**Lodi Unified School District – Pre Bid RFI responses & clarifications for the following schools for all the questions received upto April 3<sup>rd</sup>, 2019**

**T&A - RFI/Clarification # 1**

LUSD – Washington School -  
LUSD – John Muir School -  
LUSD – Davis School -  
LUSD – Wagner Holt School -

# ALTERNATE HP MOUNTING DETAIL

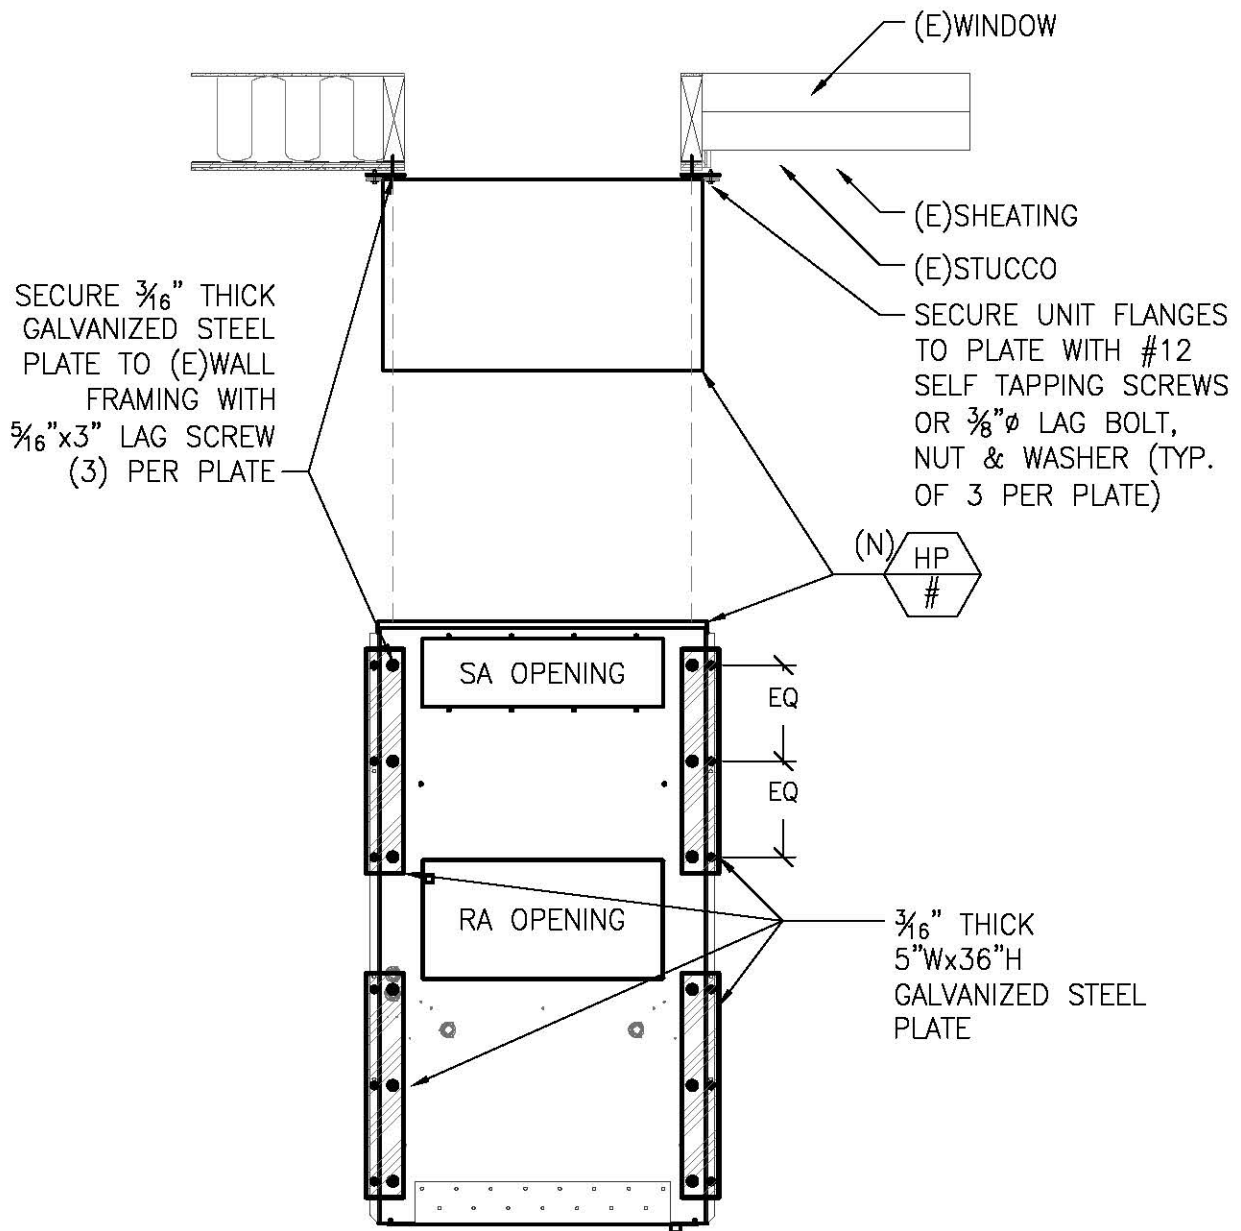
1. The site has existing Pelican controls. The existing unit does not have economizers. The new units have economizer and project requires CO2 sensors therefore new Pelican controllers are required as per specified on the plans (detail C/M5.1)
2. An alternate mounting detail for the Heat Pump (HP) unit to the existing wall has been provided to avoid impact to the windows. See attached alternate mounting detail. The detail will be submitted to DSA for review and approval. Contractor may use this detail for the heat pump mounting where it applies.
3. Provide a drywell for the heat pump unit serving Classroom # 1,2,3,9 and 10. See attached drywell detail.
